Intel386™ EX Embedded Processor

Specification Update

August 2004

Order Number: 272873-011

1. Watchdog Timer (WDT) Bus Monitor Failure During Bus Pipeline Operation

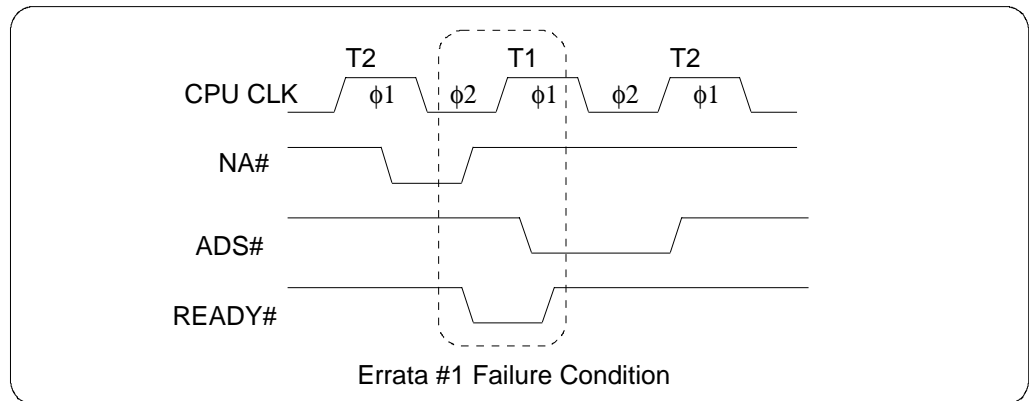
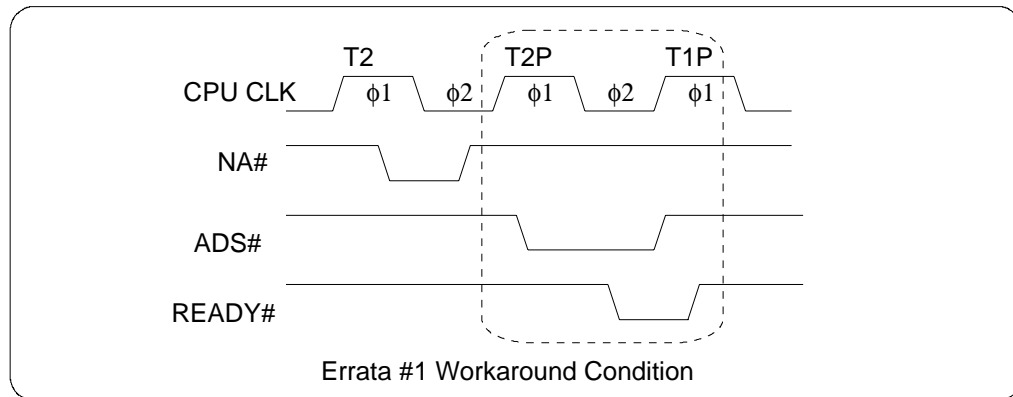
Problem: The errata applies to the WDT unit when using the Bus Monitor Mode and Bus Pipeline operation. If a pipelined bus cycle is requested at the same time the current bus cycle is completed, the WDT down counter is not reloaded or stopped. This condition means that the WDT could time-out and erroneously report a system failure. The waveform below shows the errant condition.

The errata condition is caused by the system generating READY# immediately after NA# has been requested, and a T1 cycle is generated (rather than a T2P cycle). Essentially, the system is requesting a pipelined access, but does not need it because READY# has been returned. Such a condition is not typically expected when using the pipeline feature.

Implication: Applications that use the bus monitor mode of the WDT need to be aware of this condition. If bus pipelining is not used, the errata can be ignored. If bus pipelining is used, look to the workaround description below to ensure the errata condition is avoided.

Workaround: Ensure that READY# is not generated after a pipelined bus operation is requested. See the example waveform below.

30. HLDA Inactive To HOLD Active Arbitration Could Improperly Float The Bus

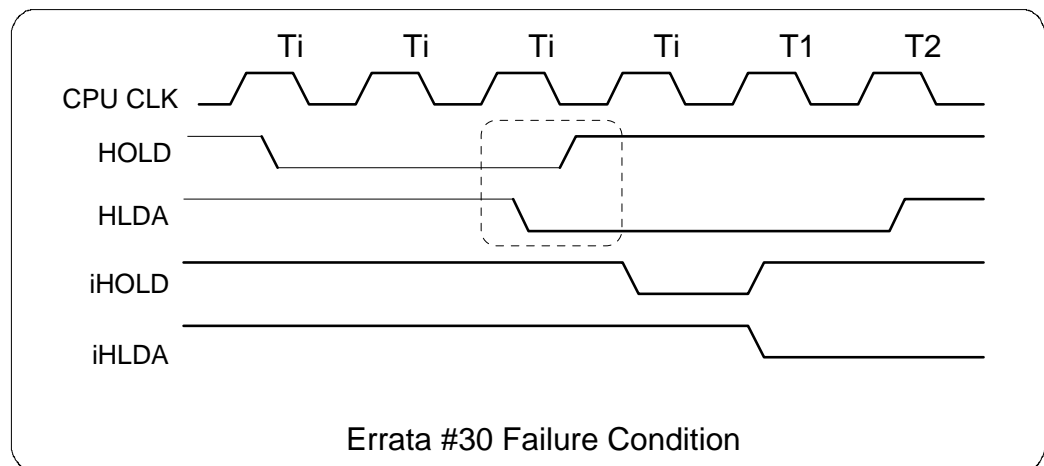
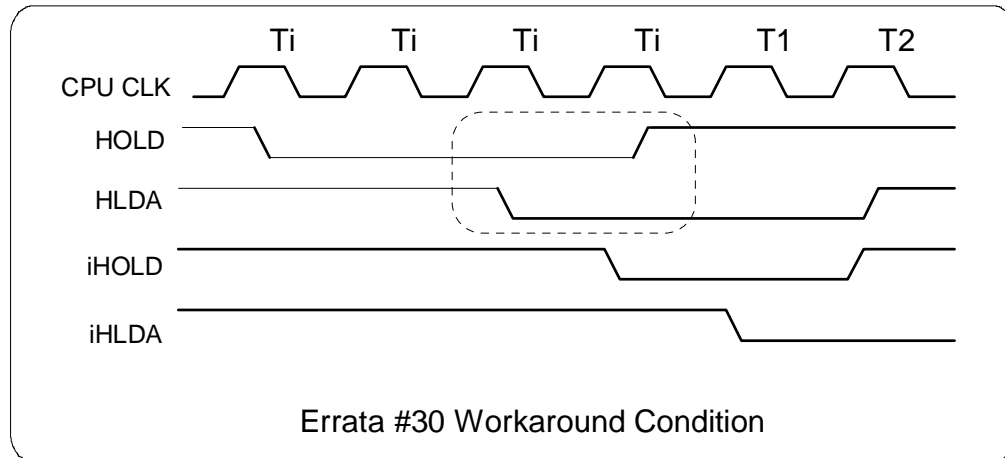
Problem: In a HOLD/HLDA cycle the HOLD signal must not be re-asserted until after HLDA is returned inactive. If, however, HOLD is asserted in the same T-state that HLDA goes inactive a problem may occur where the bus arbiter relinquishes control to the core and at the same time floats the bus by asserting the HLDA pin. The following waveform shows the conditions that cause this error. The signals iHOLD and iHLDA are internal signals and represent the HOLD input to the core and the HLDA output from the core (equivalent to the HOLD and HLDA signals on a Intel386™ SX processor). In this diagram a T1 occurs because a request was pending by the core during the previous HOLD cycle. One T-state after the arbiter releases the bus (HLDA = 0) it removes its iHOLD, and then the core removes iHLDA. As soon as the iHLDA is released, the T1 state starts. However, because of the timing of the next HOLD request, the bus arbiter re-asserts iHOLD and HLDA even though the core has not asserted iHLDA. The result is that the core continues to run its bus cycle and, at the same time, the bus arbiter has floated the external bus. It is also possible for the following to occur when HOLD/HLDA arbitration is at issue: HOLD is driven active during the T1 or Tw of a valid bus cycle. The processor begins the next bus cycle and generates HLDA. HLDA is active for only one T-state. ADS# is extended through the bus cycle. The alternate bus master sees the HLDA and performs its bus activity. HOLD is then driven inactive and the bus is returned to the Intel386™ EX Processor. At this point there is bus contention.

It is also possible for the following to occur when HOLD/HLDA arbitration is an issue: HOLD is driven active during the T1 or Tw of a valid bus cycle. The processor begins the next bus cycle and generates HLDA. HLDA is active for only one T-state. ADS# is extended through the bus cycle. The alternate bus master sees the HLDA and performs its bus activity. HOLD is then driven inactive and the bus is returned to the Intel386™ EX Processor. At this point there is bus contention.

Workaround: Synchronize the external HOLD request such that it does not go active until at least one T-state after HLDA is inactive. See the following example waveform.

Another workaround is to delay the generation of HOLD until the last T2-state of a valid bus cycle (excluding refresh cycles or INTA cycles).

Figure 3. HOLD with Short REFRESH Interval

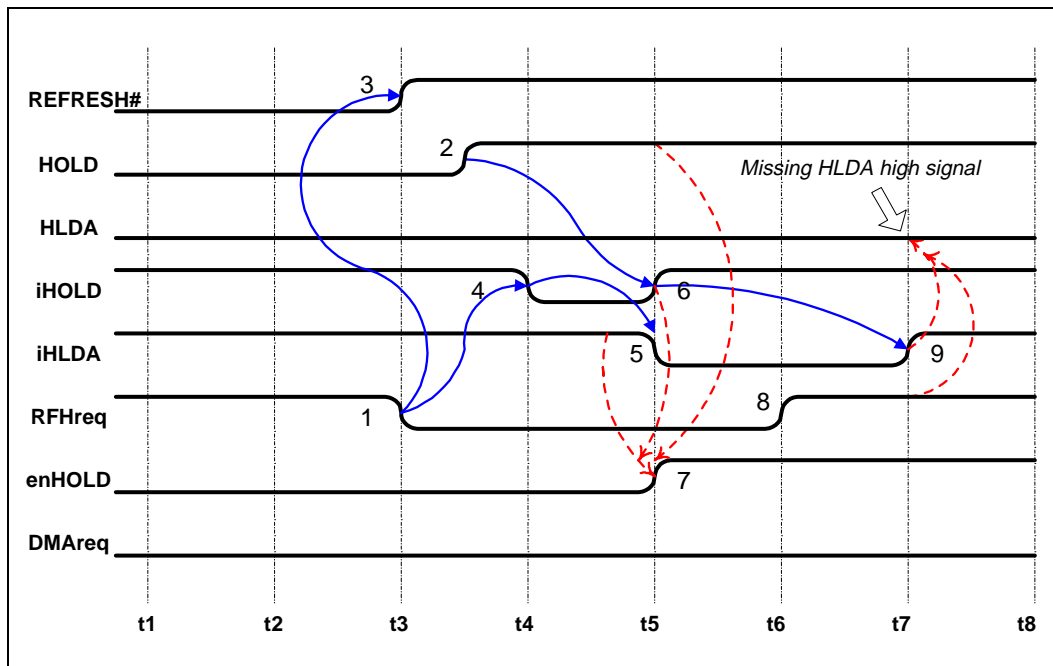
1. For system designs that use both HOLD and the internal Refresh Control Unit, the conditions are as listed in a, b, and c.
 - a. A small RFSCIR register value can cause the current refresh cycle and the next refresh cycle to almost overlap. Refer to Figure 3. When such a condition exists, there is a possibility that the refresh latency will cause a gap between the current refresh terminating (t3) and the next refresh (t6). This will create a problematic window if HOLD is asserted during that time. The minimum RFSCIR count that can be used without causing this problem depends on HOLD latency which is related to bus activity. HOLD latency is similar to refresh latency since they both generate an iHOLD request to the core. HOLD latency is basically a factor of wait states, locked cycles and special cycles such as interrupts. Worst case conditions should be used and can be calculated based on the information on page 6-37 (Hold Signal Latency) of the Intel386™ EX Embedded Microprocessor User's Manual (order number 272485-002). If the RFSCIR is a few cycles longer than the maximum calculated HOLD latency plus refresh duration, the problematic window will not exist. This condition should not happen in a typical customer design, since the RFSCIR value is usually larger than the worst case minimum value. To avoid this error, no workaround is needed as long as the RFSCIR value is greater than the recommended minimum value. The minimum RFSCIR can be roughly calculated as follows:

Figure 3 shows Condition #1a where an external HOLD and refresh request conflict can occur. The table below describes each signal name used:

Assert HOLD only after a valid ADS# has been asserted signifying a new, valid bus cycle (use ADS# to qualify HOLD). See the Intel386 EX Embedded Microprocessor User's Manual for explanation of valid bus cycles.

Figure 4. Quick HOLD Assert and Deassert with Slow REFRESH Interval

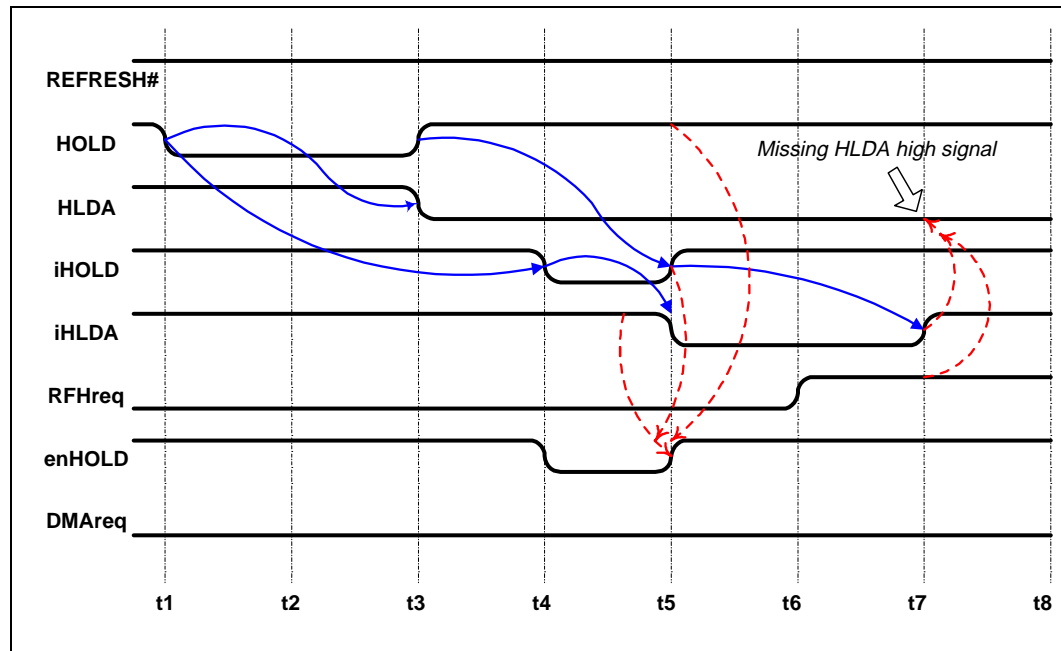
- b. HOLD is removed and reasserted within one bus cycle. Refer to Figure 4. This condition will cause the problematic window with fast iHOLD deassertion (t4) and assertion (t5). Note that if HOLD is deasserted because of pending REFRESH and reasserted again within one bus cycle, the problem will not occur since the iHOLD signal is never deasserted due to refresh. The reassertion of the HOLD would then be serviced upon completion of the refresh.

Workaround 2: Deassert HOLD if HLDA is not asserted within the worst case HOLD latency. This can be implemented with external logic that times-out if a HLDA signal is not asserted after the hold latency interval. Note: Slow deassertion of HOLD can increase refresh latency. The user should make sure that the errata is not induced because of late HOLD deassertion when refresh is pending. Added refresh latency can increase the potential for overlapping refresh requests (causing the error). In this workaround, HOLD should be qualified with the ADS# signal. This entails deasserting HOLD if a HLDA has not been returned and no valid ADS# signals have occurred within the time-out period for worst case HOLD latency.

Figure 5. DMA, HOLD and REFRESH with Normal Interval

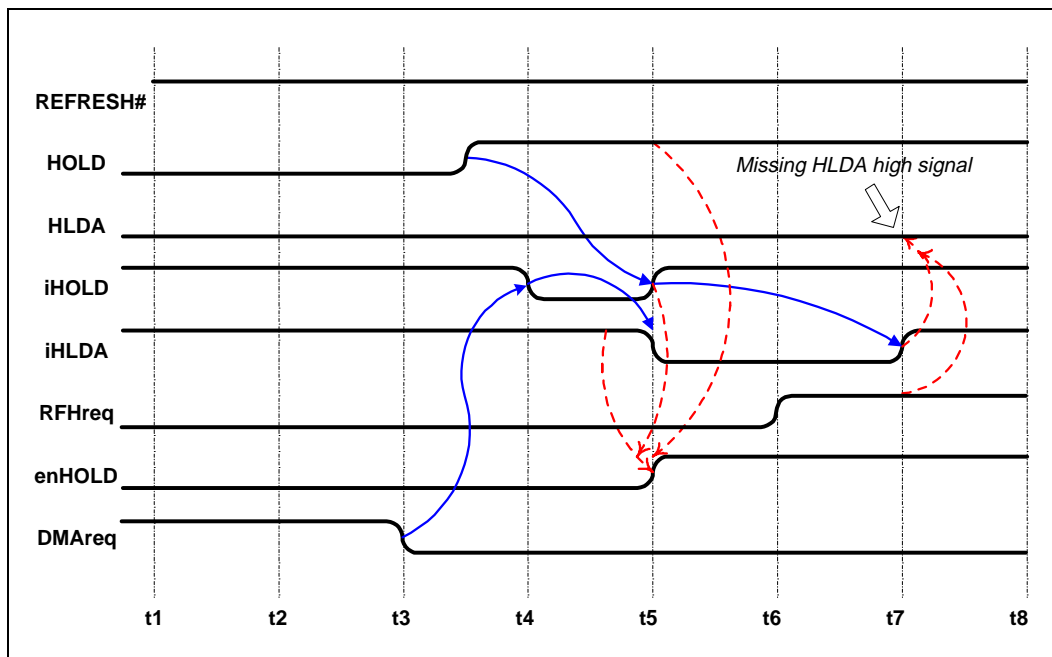
For the errata to occur, HOLD must be asserted asynchronously at any cycle such as in an idle cycle. Refer to Figure 5. Termination of DMAREQ at time t3 with assertion of HOLD at time t4 creates the problematic window. If there is a refresh request at time t6, the HLDA is blocked and will not go active at time t7. If HOLD is synchronized at the beginning of a new valid bus cycle (except for REFRESH), HLDA will always be asserted since the problematic window will not occur.

Note: DMAREQ is a signal internal to the processor. This signal is not always within the user’s control and could be internally deasserted, such as in autoinitialize mode. To avoid issues with this type of situation, it is recommended that the user deassert the external request DREQ after the last transfer has completed. It is further recommended that DREQ only be deasserted after a valid DMA acknowledge (DACK# goes low) has been returned. If a DREQ is held active and then deasserted during or shortly after the autoinitialize sequence, the problematic window can be induced and cause the errata to occur. See errata #28 for additional details on DMA programming restrictions.

Figure 6. Two DMA Channels in Cascade Mode with Internal RCU Anomaly

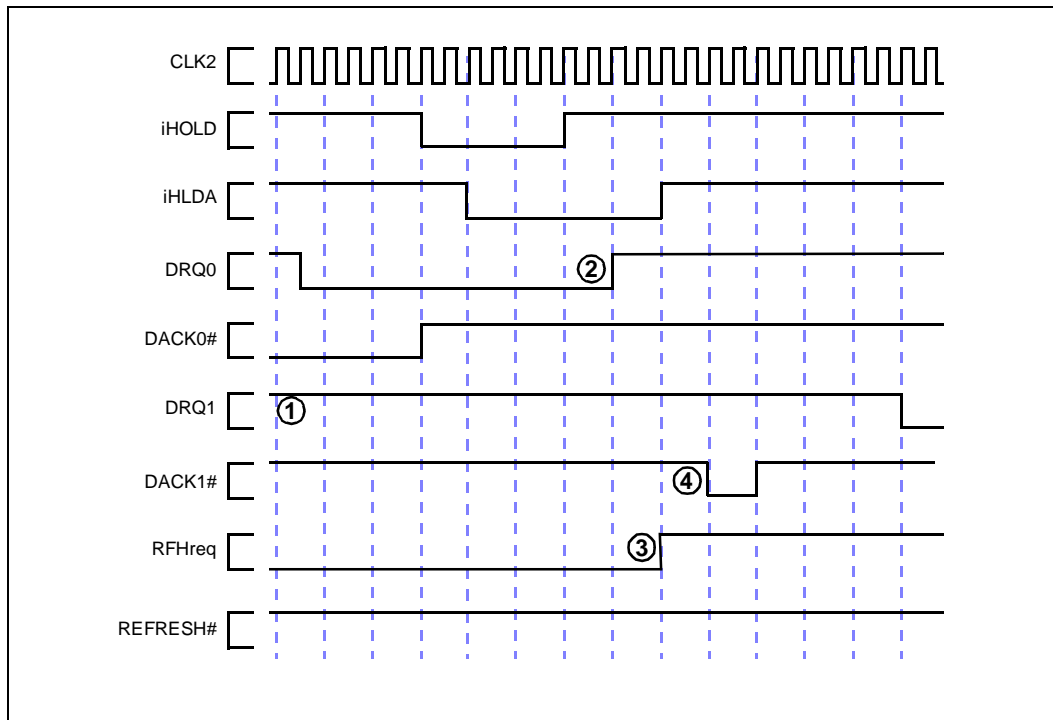
This anomaly is shown in [Figure 6](#) (internal signals used in the diagram are described in the table below). Both DMA channels are in cascade mode and Channel 1 is programmed to have the lowest priority.

The lower priority DMA channel requests the bus by asserting DRQ1 (see 1 in Figure 6). The higher priority channel requests the bus by asserting DRQ0 before the iHLDA has returned from the core (see 2 in Figure 6).

While the Bus Arbiter Unit is in the process of arbitrating priorities between the DMA channels, an internal refresh request signal (RFHreq) is asserted (see 3 in Figure 6) one PH1 cycle before the DMA acknowledge is granted (DACK1# asserted - see 4 in Figure 6). This scenario confuses the bus arbiter and the DMA acknowledge is given to the *lower* priority DMA channel. The arbiter believes the acknowledge was granted to the *higher* priority channel. The DACK1# is quickly taken away from the lower priority channel due to a pending refresh request. DMA channel 1 drops its request, apparently releasing the bus for a REFRESH cycle, but the arbiter is waiting for the higher priority channel to drop its request (DRQ0); this never occurs, since the acknowledge was never granted (DACK0#), and the system hangs.

10. 272485-002, Section 6.3.6, Page 6-29, Figure 6-11.

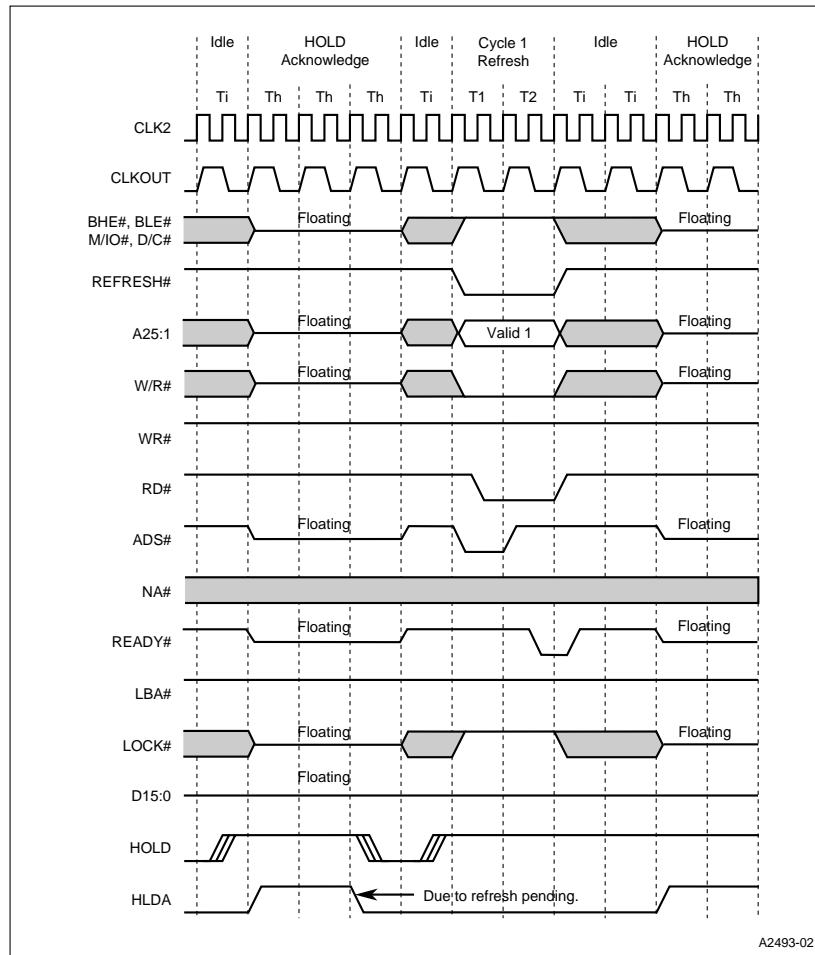
Issue: Changed “BHE#, BLE#, M/IO#, D/C#” to read “UCS#, CS6:0, BHE#, BLE#, M/IO#, D/C#”.

Figure 12. Transmit Data by Polling

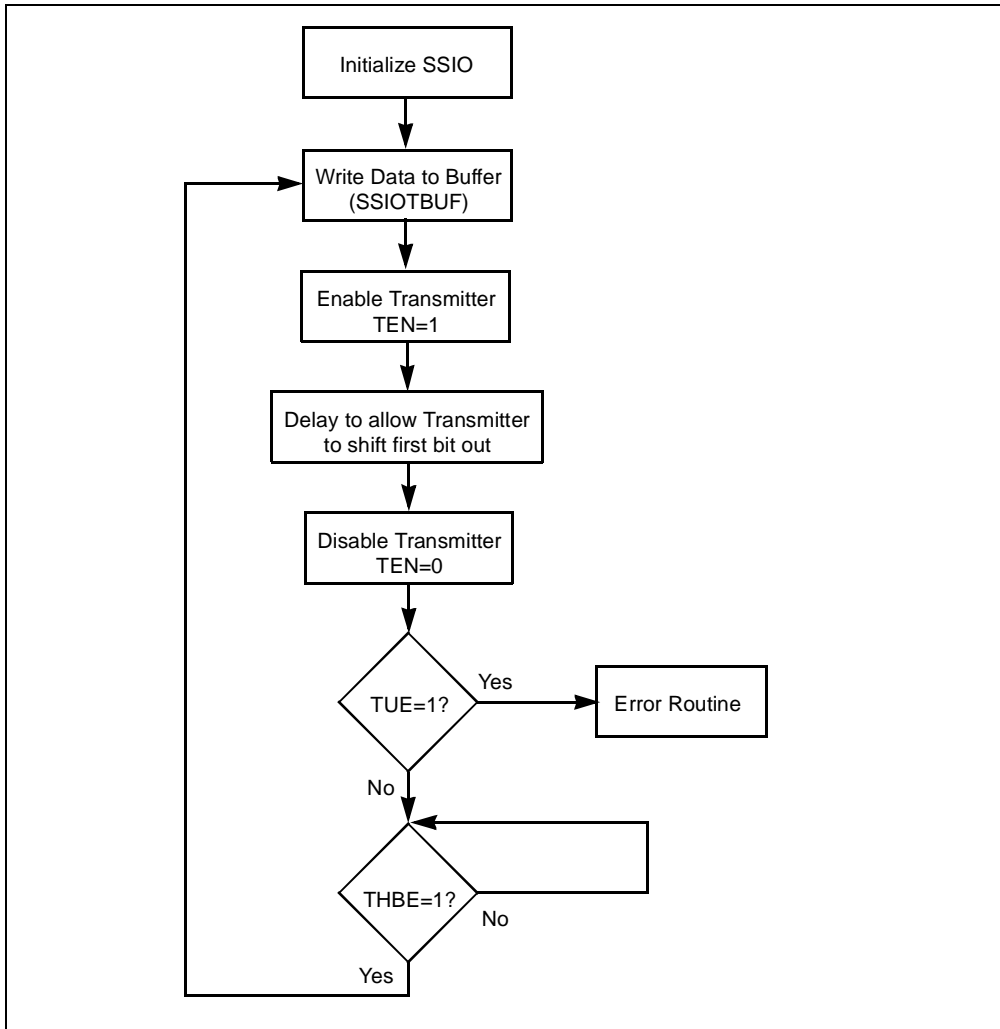
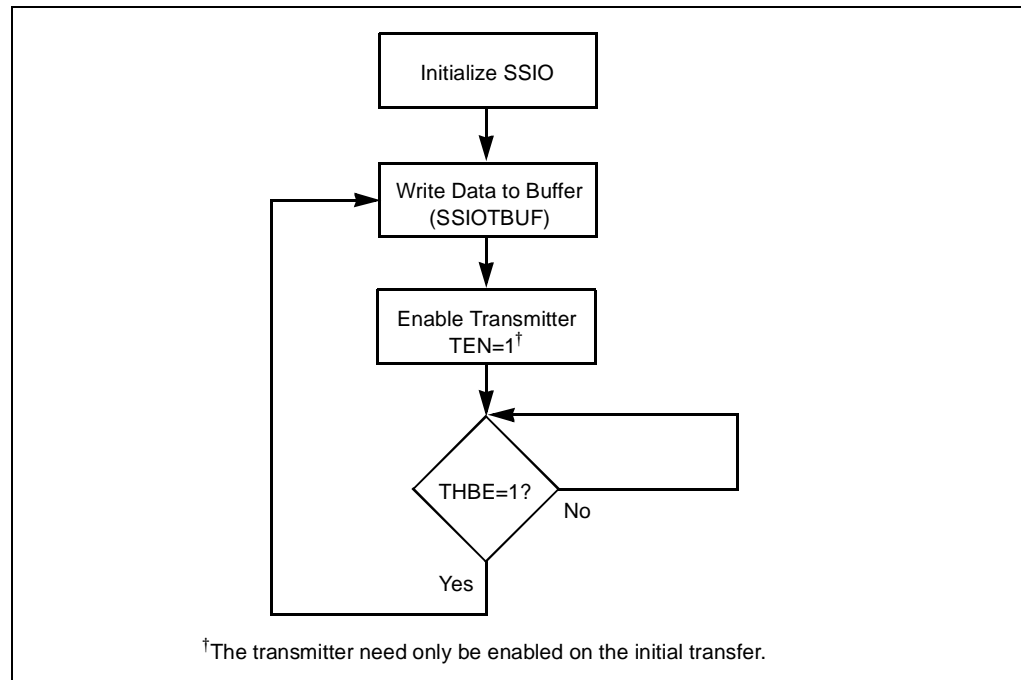
Issue: Replace figure 13-8 with Figures 13-8a and 13-8b as shown below.
